Accessibility Evaluation

Monroe County Polling Location

Emmanuel Church
1503 W That Rd
Bloomington, IN 47403
Accessibility Evaluation
Inspection Date: 03/06/2026
Inspectors: Chris Jackson

Finding: 1

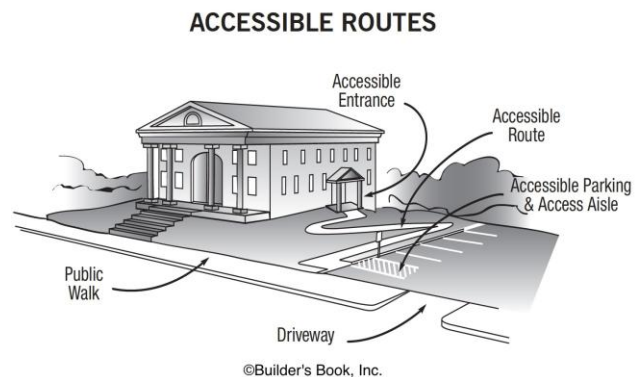
The access aisle is not located on an accessible route of travel to the accessible building entrance.

2010 ADAS Section: 208.3.1, 502.3

Add cones to create a 36" wide protected path of travel along the curb leading to the entrance. (See additional photograph for example cone placement.)

Finding: 3

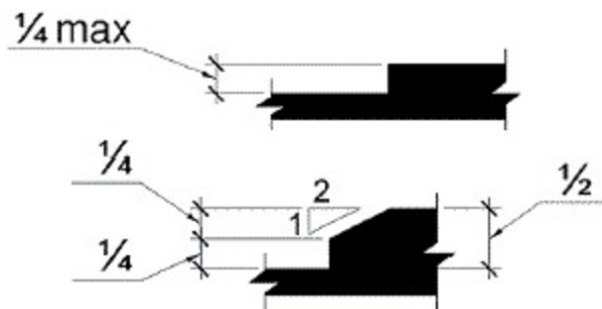
The threshold is greater than 1/2 inch high.

2010 ADAS Section: 404.2.5

Use primary front door instead of side door and have a poll worker or appropriate signage direct voters through double doors into the gymnasium space. (See additional photograph for alternate accessible route.)

If this door is used, add a threshold reducer.
